Preapplication Safety Evaluation Report for the Sodium Advanced Fast Reactor (SAFR) Liquid-Metal Reactor

U.S. Nuclear Regulatory Commission

Manuscript Completed: September 1991
Date Published: December 1991

This safety evaluation report (SER) presents the results of a preapplication design review for the standard modular Sodium Advanced Fast Reactor (SAFR) liquid metal reactor (LMR), NRC Project No. 673. The SAFR conceptual design was submitted by the U.S. Department of Energy (DOE) in accordance with the U.S. Nuclear Regulatory Commission's (NRC) "Statement of Policy for the Regulation of Advanced Nuclear Power Plants" (51 Federal Register 24643). This policy provides for early Commission review and interaction with designers and licensees. The standard SAFR design consists of four identical reactor modules, referred to as "power paks," each with a thermal output rating of 900 MWt, coupled with four steam turbine-generator sets. The total electric output is 1400 MWe. The reactors are liquid sodium cooled and use metallic-type fuel, a ternary alloy of U-Pu-Zr. The design includes passive reactor shutdown and decay heat removal features.

Figure A.17 SUPERSYSTEM code prediction for SAFR pump seizure: Power and key temperatures.

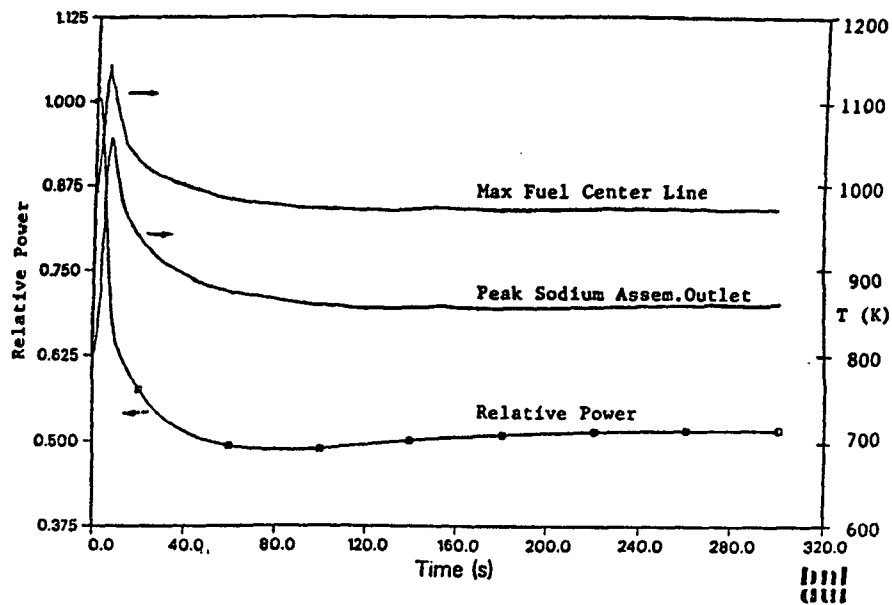
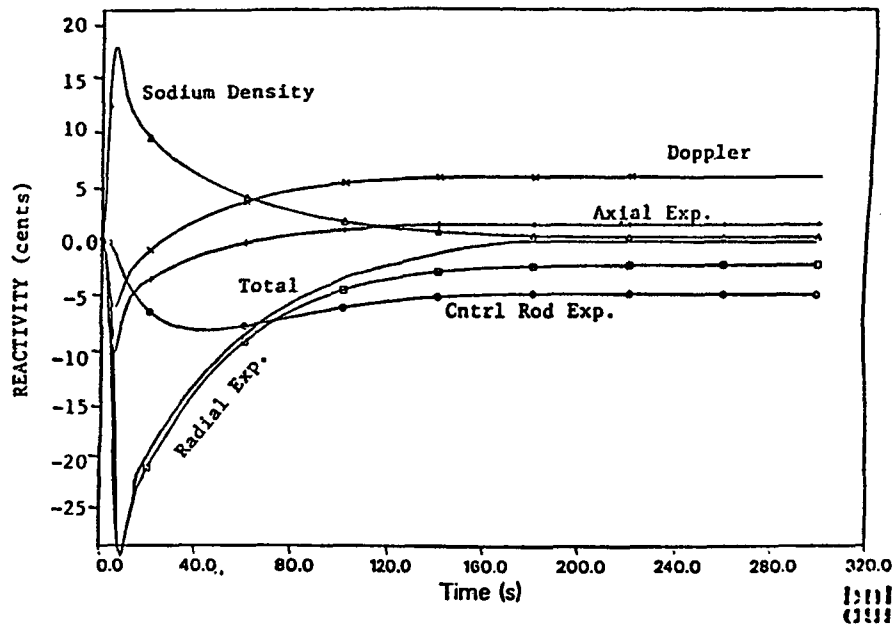
The prescribed flow condition from MINET was simulated in SUPERSYSTEM and the results are presented in Figures A.17 and A.18. The power in Figure A.17 drops immediately to 50 percent and reestablishes criticality at about 52 percent of rated power. The reactivity feedbacks that make up the passive response to a sudden loss of flow in a metal-fueled core are shown in Figure A.18. The initial effect is from the Doppler and axial expansion feedback. The reduction in coolant flow causes heatup. Within the first few seconds, Doppler and axial expansion insert -6% and -9% respectively. The drop in sodium flow, coupled with the increase in fuel temperatures, leads to increased sodium temperatures, generating a positive feedback. This added about $+17.5\%$ of reactivity at its peak, and slowly returned to zero around 200 seconds when the reactor reestablished criticality. Higher sodium temperatures increase temperatures in the surrounding structures and the load pads, activating the radial expansion. From Figure A.18, it is clear that the radial expansion feedback is the dominant mitigating factor.

The Doppler reactivity only inserts about $+7\%$ of reactivity after the power is reestablished at 52 percent of nominal, as shown in Figure A.18. A negligible Doppler, and the correspondingly reduced temperature defect, make it possible for the small reactivities generated in the metal-fuel core to force the power to a much lower level.

Despite the challenge of this event, safety margins are adequate. SUPERSYSTEM calculated the peak fuel center line temperature (see Figure A.17) to be 1134 K (1581°F), which leaves a 232 K (419°F) margin to the solidus temperature. The peak assembly outlet temperature was calculated to be 1050 K (1431°F), which is well below the sodium saturation temperature of 1222 K (1740°F). Furthermore, the feedbacks reduced the power level to a point at which the maximum fuel center-line temperature and the maximum sodium temperature in the core are low enough at the new quasi-static condition that the system could remain at this condition indefinitely without serious consequences.

Figure A.19 SUPERSYSTEM code prediction for SAFR UTOP and LOF : Power and core flow.

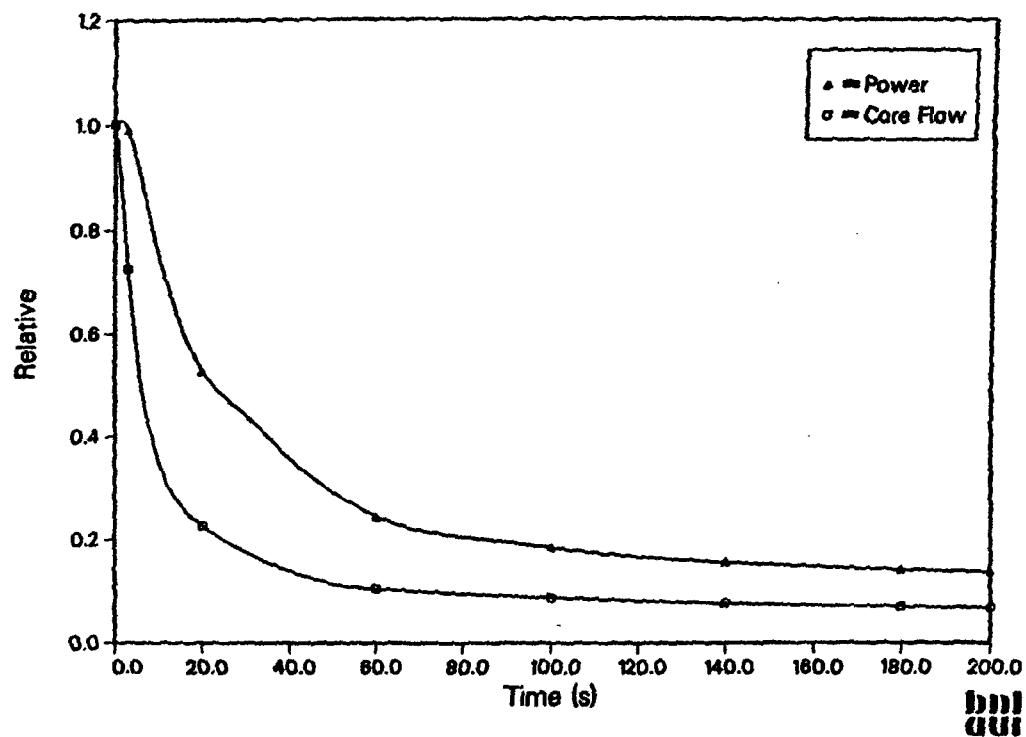
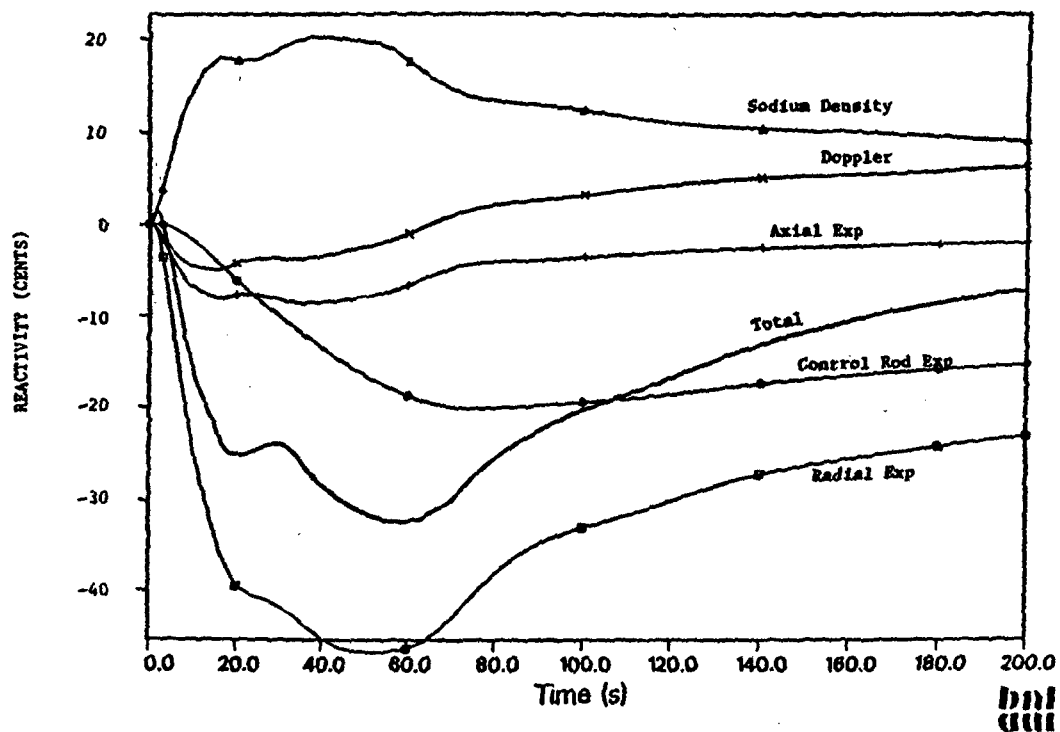
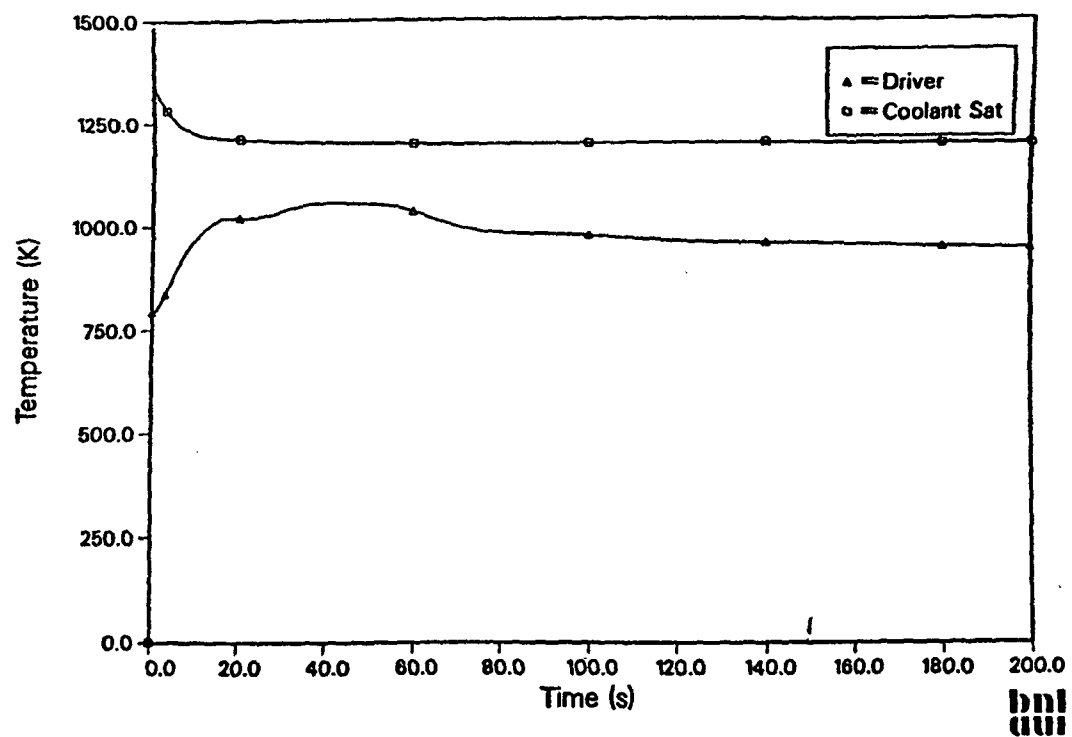
The SUPERSYSTEM results are shown in Figures A.19 through A.21. The power and flow history are shown in Figure A.19. The power increases a few percent and then drops off, by 200 seconds, to 14 percent of nominal power, and will continue to drop because the total reactivity remains

negative (see Figure A.20). The plot of the reactivities demonstrates that the radial expansion feedback dominates the initial response of the core and, therefore, controls the drop in power. The control rod expansion and the radial expansion are the most significant negative feedbacks by the end of the 200-second transient. The power decreases because the average system temperature increases (which activates the radial expansion, control rod drive line expansion, and axial expansion for the negative feedbacks, while causing a positive response only from the sodium density), generating a net negative feedback.

The margins for this event are large. The peak sodium temperature was predicted to be 1060 K (1449°F), leaving a 150 K (270°F) margin to sodium boiling (see Figure A.21). The peak fuel centerline temperature was calculated to be below 1089 K (1500°F), which makes the margin to fuel melting greater than 277 K (499°F). No cladding damage would be expected from eutectic penetration.
